MEMORANDUM

DATE: August 2, 2016
TO: Robert Hawthorne (PDX Living, LLC)
FROM: Todd Prager, AICP, RCA #597, ISA Board Certified Master Arborist
RE: Updated Tree Plan for 5505 SE 47th Avenue

LAND DIVISION LU-16-195824-LDP

Figure 1. Sample profile for areas within Critical Root Zones. Depth of rock is dependent on grading. Technique based on best management practices.

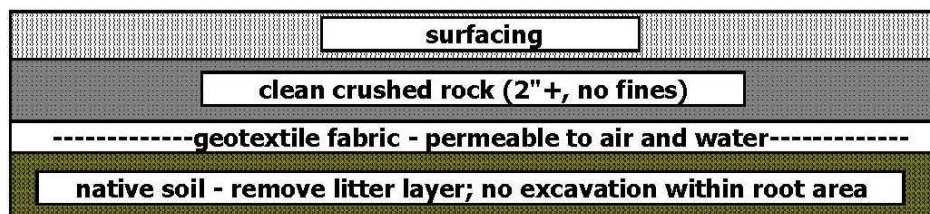
The only significant change to the tree protection plan in our August 2, 2016 report is the new driveway location. The updated site plan in Attachment 1 includes a new driveway that encroaches within the 6x tree protection zone of T1. The driveway should either be redesigned so it is outside the 6x tree protection zone or constructed using a modified pavement profile as shown in Figure 1 to limit impacts to the tree's root zone:

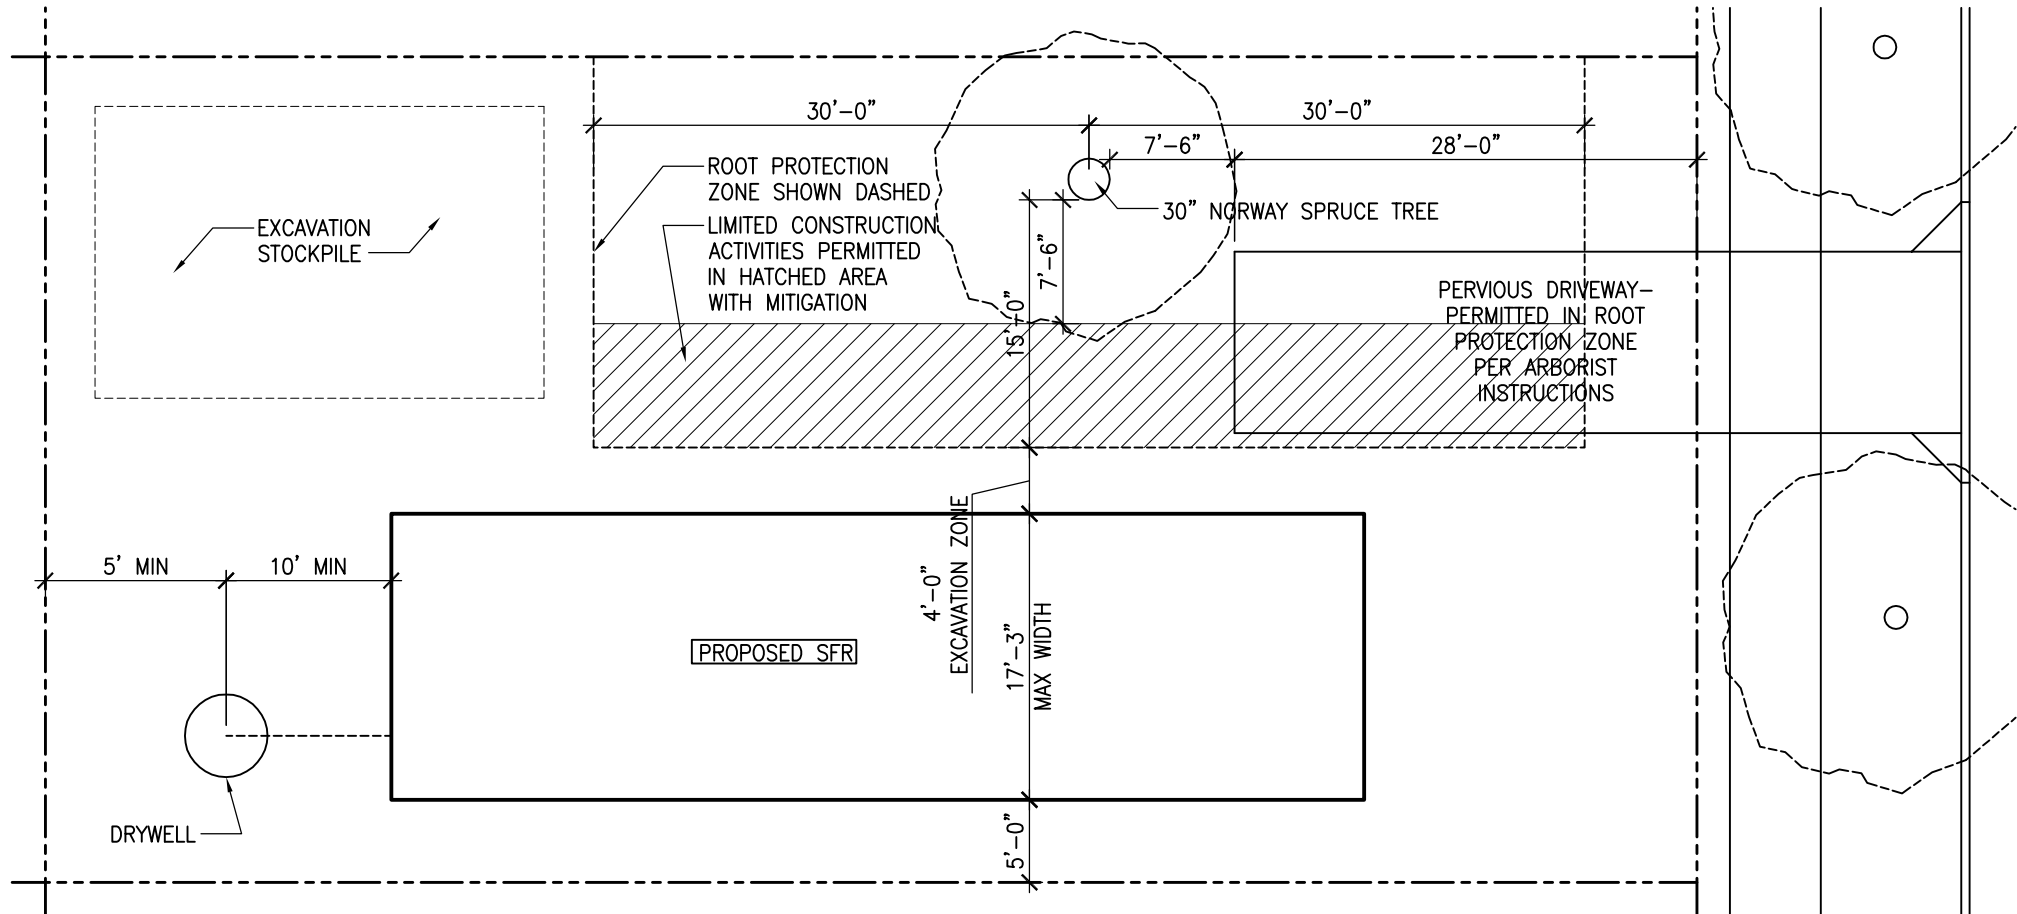
The site plan sketch was intended as a talking point to get the conversation started about site design and layout, and if the spruce could be preserved by adjusting the site design and layout. I'm not saying that you have to preserve the tree, but you need to do a bit of analysis to directly address 33.630.200.C.

The arborist report needs to be amended to focus on the only tree that could be preserved at the site, the spruce tree. The arborist report should focus on approval criteria 33.630.200.B, and C. Read through those code sections for details. Link here: <http://www.portlandoregon.gov/bps/article/53434>

Attachment 1 includes the updated site plan for the project. As shown in Attachment 1, the spruce (T5) is within the proposed footprint of the house on parcel 2.

The project team has created an alternative site plan in Attachment 2 given our 15 foot recommended setback from T5. Note that a five foot setback is required from the south property line and four feet of space is required for excavation of the basement and foundation. Based on these constraints, the proposed house would be 17.25 feet wide. The project team has concluded that constructing a house with these dimensions would

Attachment 1 includes the updated site plan for the project. Since the spruce (T5) is

Street trees T7 and T9 will be retained and protected. Tree protection fencing will be necessary surrounding T9 as shown in Attachment 1. T7 will not require tree protection fencing because it is far away from proposed construction.

Parcel 2 has 50 feet of street frontage along SE 47th Avenue so two street trees are required. Due to the setback requirements for driveways and adjacent trees, there is only room for one street tree. A possible street tree species and location is shown on the updated site plan in Attachment 1. A street tree fee in lieu of \$450 will be required for the other required street tree.
